# Azoteq Product Change Notice:

## IQS333

**Issued Date: 15 December 2014**

**PCN Number: ACN\_333\_01**

**Figure 2.1 Changes in Package Dimensions. Drawing for illustration only, not to scale.**

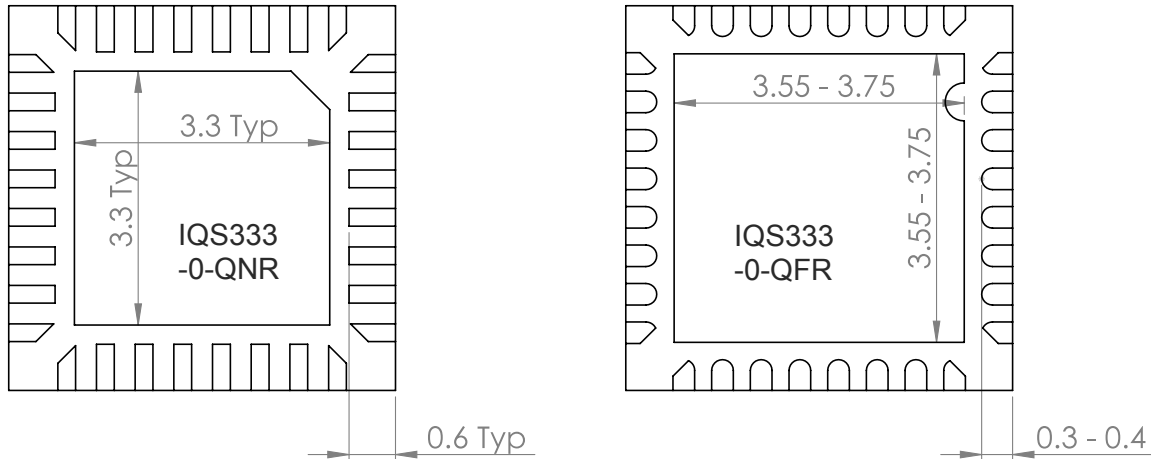
The overall physical size of the part ( $l \times w \times h$ ) and pitch of the pins did not change.

The mechanical dimensions of the saddle and length of the pins have changed from the old part (IQS333-0-QNR) to the new part (IQS333-0-QFR). The new dimensions are given below:

The bonding diagram, and therefore the pin out, has not been affected.

Since the package has changed, an update to the PCB footprint is required.

Change the PCB footprint during the next board design cycle to facilitate placing the new part.
